AMENDMENT OF SOLICITATION/MODIFICATION OF CONTRACT			1. CONTRACT ID CODE		PAGE 1 OF PAGES 3	
2. AMENDMENT/MODIFICATION NO. 0003		3. EFFECTIVE DATE 03/16/10		4 REQUISITION/PURCHASE REQ NO. N/A		PROJECT NO. (If applicable) 07-457957

14. DESCRIPTION OF AMENDMENT/MODIFICATION (Organized by UCF section headings, including solicitation/contract subject matter where feasible.)						
DESIGN AND CONSTRUCT NEW AND MODIFIED EXISTING INFRASTRUCTURE REQUIRED FOR HOMEPORTING NEW FAST RESPONSE CUTTERS (FRC) AT US COAST GUARD BASE SUPPORT UNIT (BSU) MIAMI, MIAMI BEACH, FLORIDA.						
(SEE CONTINUATION PAGE)						
15A. NAME AND TITLE OF SIGNER (Type or print)				16A. NAME AND TITLE OF CONTRACTING OFFICER (Type or print)		
15B. CONTRACTOR/OFFEROR (Same as Item 8)		15C. DATE SIGNED		16B. UNITED STATES OF AMERICA BY		16C. DATE SIGNED
_____ (Signature of person authorized to sign)				_____ (Signature of Contracting Officer)

SHEET TITLE
HOMEPORTING FRC CUTTERS
USCG BSU
MIAMI FL
GENERAL
CONSTRUCTION PHASING PLAN

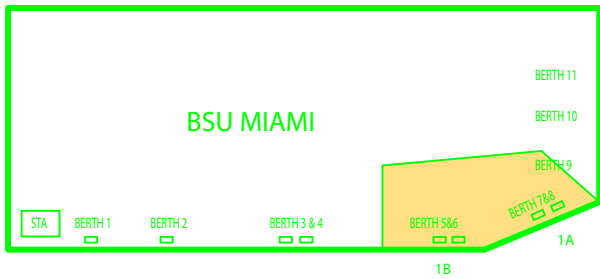
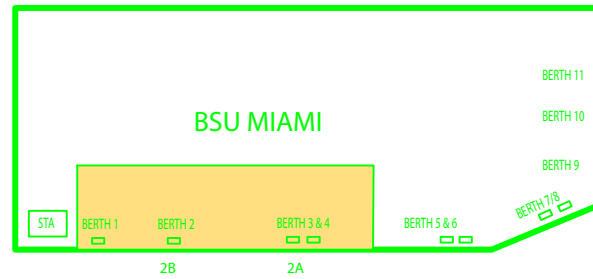
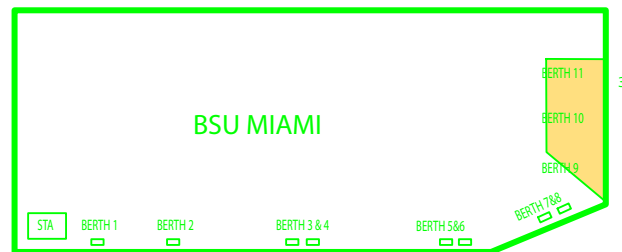
3. Replace Drawing A07457959G002 with drawing A07457959G002,Rev

ISSUE		
MARK	DATE	DESCRIPTION
A	03/15/10	REVISED PHASING PLAN

1.6.1 Sequence of Work. The following phasing plan for sequencing work in the waterfront areas is based on the new vessel berths as shown on the RFP drawings. Work at new berth 12 (old berth SP-9) is not phase dependent and may be done at any time during the construction at the discretion of the contractor.

Phase 1A: Berths 7 & 8: The existing 400 ampere shore tie outlet at "old berthing location ST-7" shall remain in service until completion of Phase III work unless the COR indicates that it may be removed prior to that time. Work shall be completed by December 17, 2010.

Phase 1B: Berths 5 & 6: Work shall be completed by January 10, 2011.

Phase 2A: Berths 3 & 4: Work shall be completed by February 25, 2011.

Phase 2B: Berths 1 & 2: Work shall be completed by April 08, 2011.

Phase 3: Berths 9-11: Work shall be completed by May 13, 2011.
